Access Compliance Report

Public Rights-of-Way

Intersection ID: 44026	Main Street: MT_HOLLY-HUNTERSVILLE_RD	Cross Street: COULOAK_DR	Location: S
ADA ID: 284F3C32C2A6	Ramp Type: Para	Initial Pass/Fail: Fail	Overall Compliance: No
Severity Score: 13.75			
Codes/Mitigation Info/Possible Solution		Field Measurements/Component Compliance

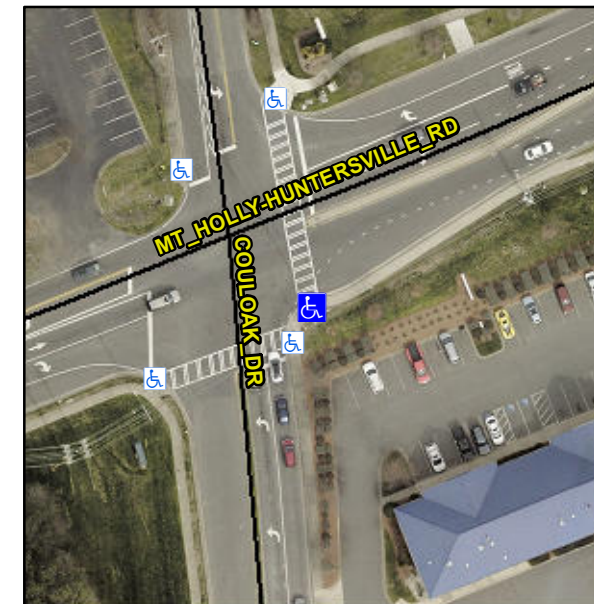
Surveyor Notes:

RT RP < 5%

PROW/ADA:

R304.3.2, R304.5.3

Possible Solutions:

Remove & Replace Entire Ramp.
